AGENDA
CITY OF CEDAR FALLS, IOWA
PLANNING AND ZONING COMMISSION
WEDNESDAY, SEPTEMBER 12, 2018
5:30 PM AT CITY HALL - COUNCIL CHAMBERS

TO: Planning & Zoning Commission
FROM: David Sturch, Planner III
Jon Resler, City Engineer
DATE: September 6, 2018
SUBJECT: Park Ridge Estates Preliminary Plat

Park Ridge Estates Preliminary Plat

PRELIMINARY
DRAWING

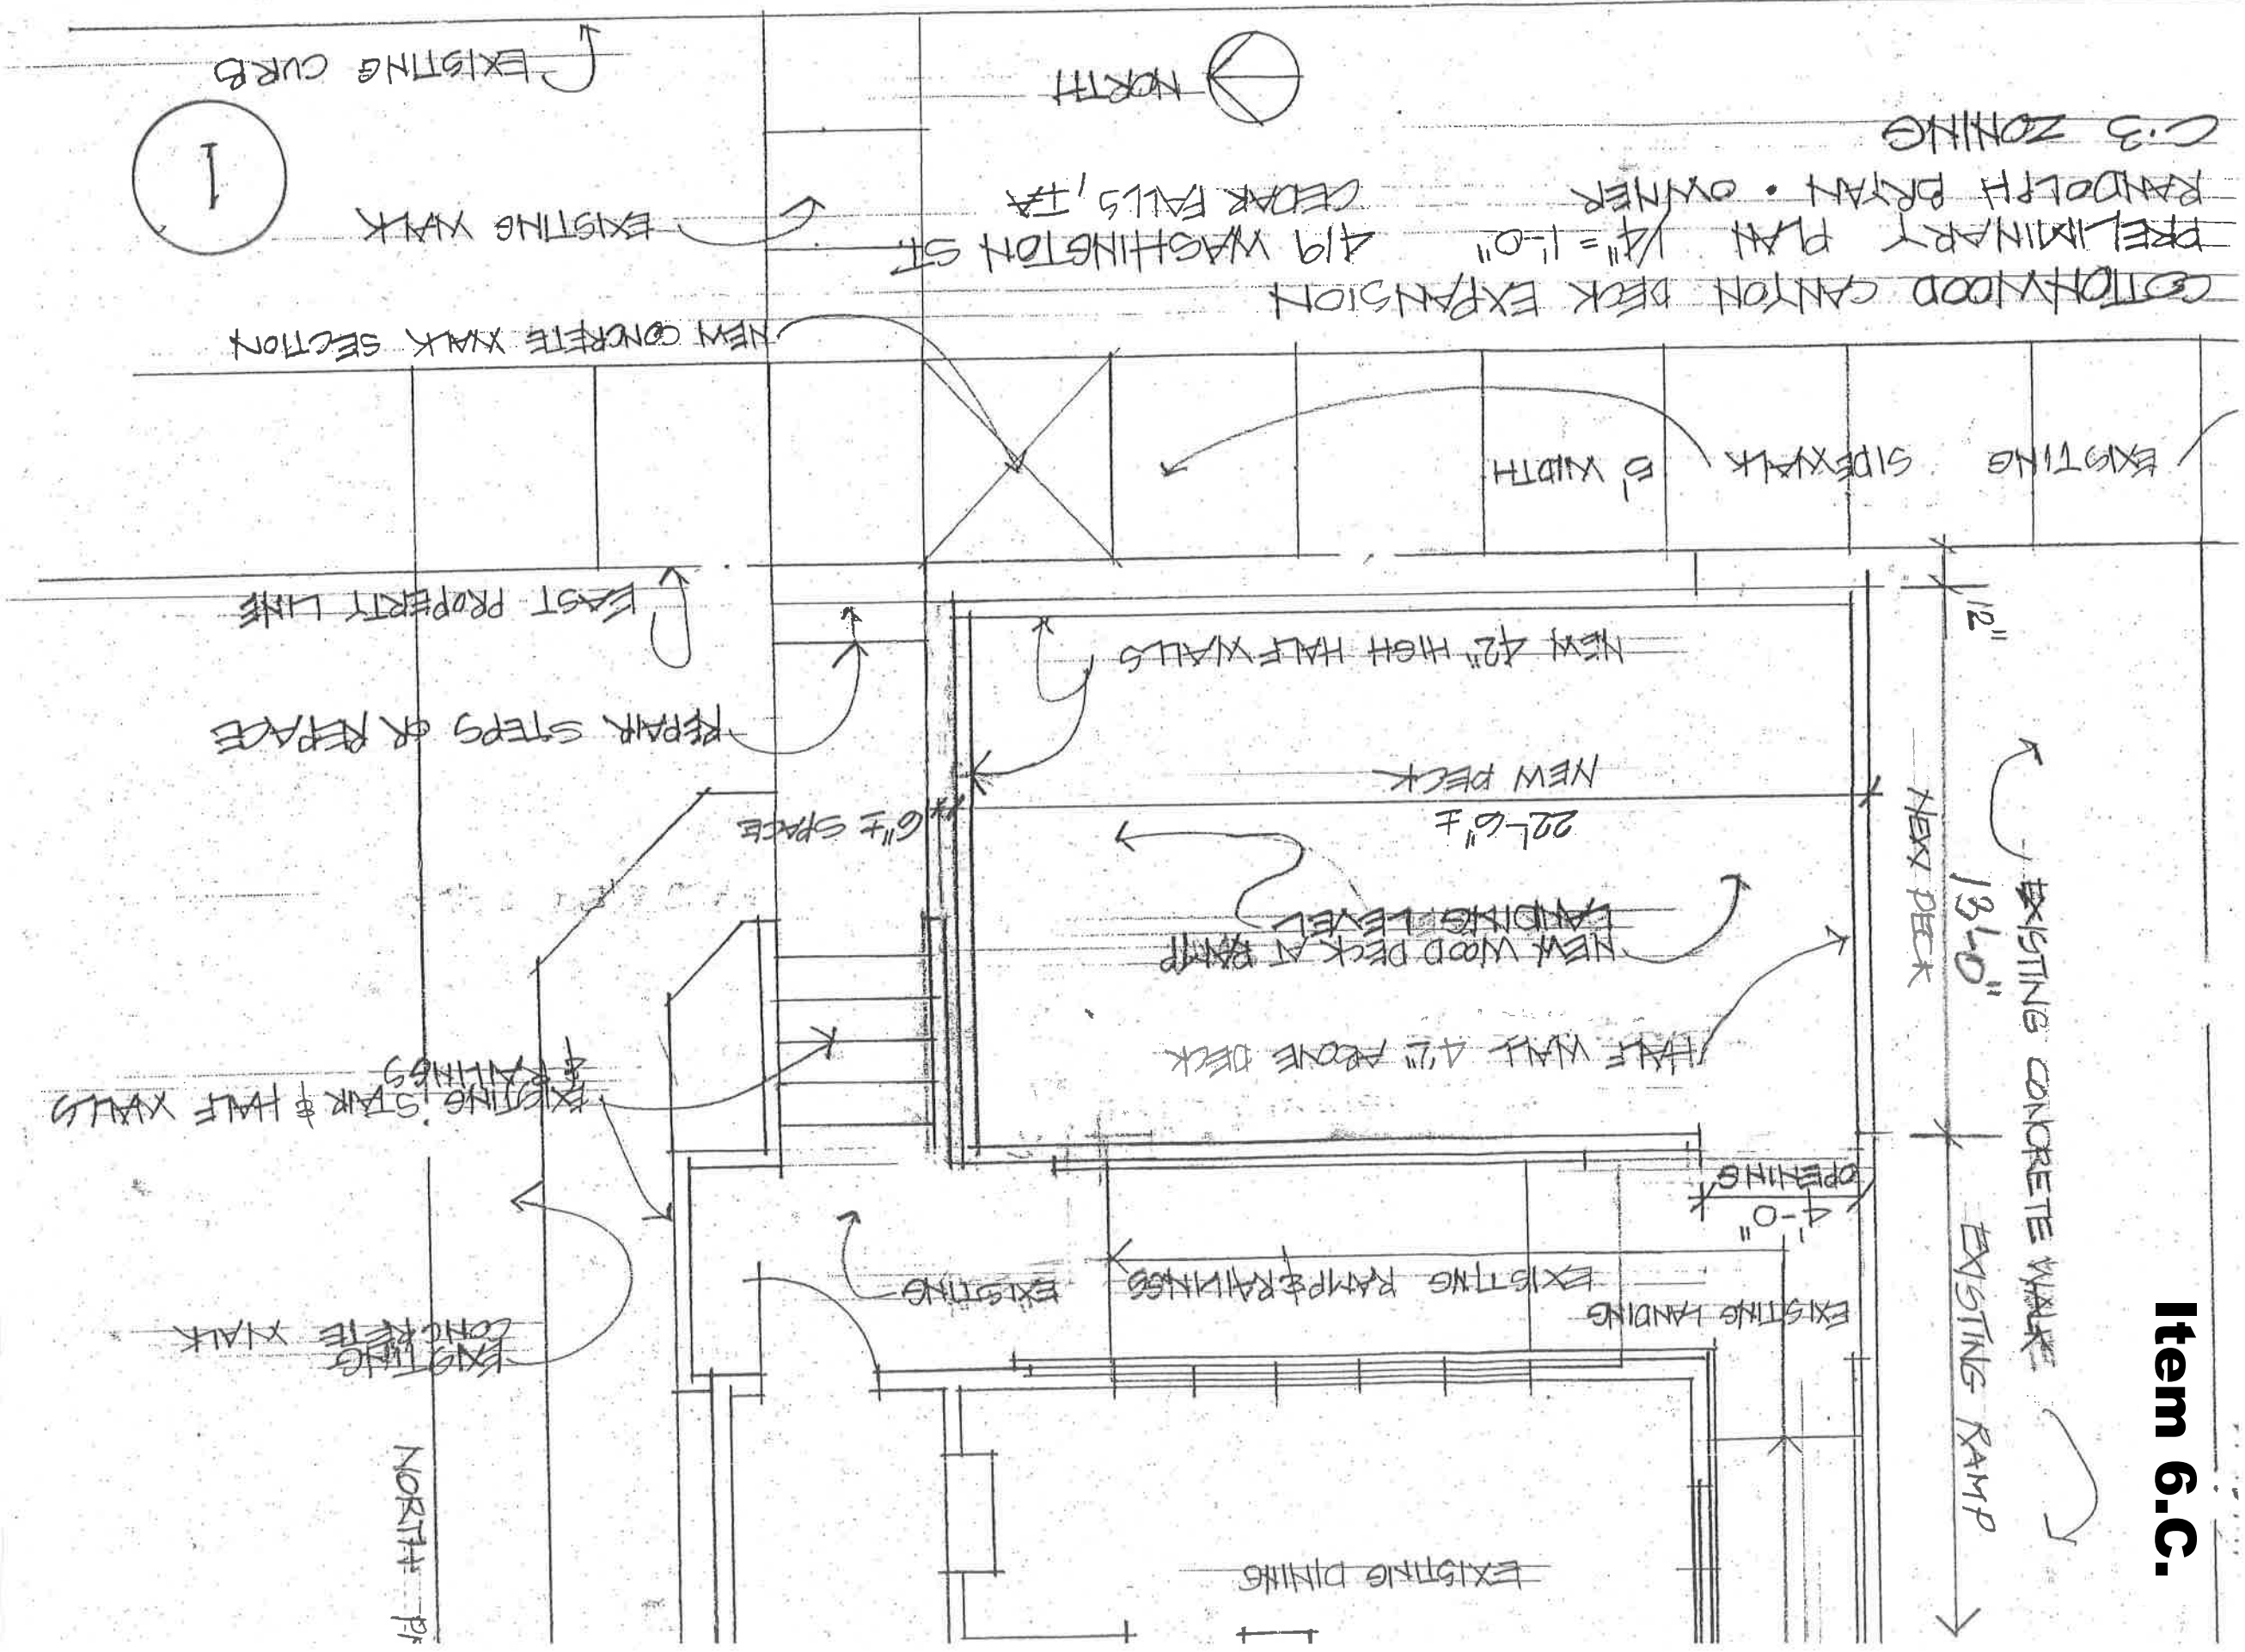
The provided drawing shows the posts of the deck exposed and area under the deck open. This will become a maintenance issue and an area for trash and leaves to collect. Screening this portion with typical porch skirting will both visually and functionally improve the

proposal as well as be consistent with best practices for porches. In addition, the vertical boards (balusters) on the deck railing (balustrade) should connect to both a top rail and a bottom rail. It is difficult to tell if this is what is proposed in the submitted drawing. Staff has discussed this issue with the applicant and he is agreeable to designing the deck railing with both a top and bottom rail to give a more finished appearance to the deck. Provided skirting to screen the underside of the porch is provided and the balustrade is designed as described above, staff finds that the criterion is met.

- The wood deck and existing wood ramp and stoop structure must be painted or stained with an opaque color that is consistent with the color of the building.
- Applicant modifies the size of the deck to ensure it is setback a minimum of 3 feet from the public sidewalk and provides a landscape plan including low shrubs for the area between the deck and the sidewalk.
- Additional details are provided for the construction of the deck. Specifically the type of skirting and balustrade details as described in the staff report.
- The liquor license is amended to include the area of the new deck.
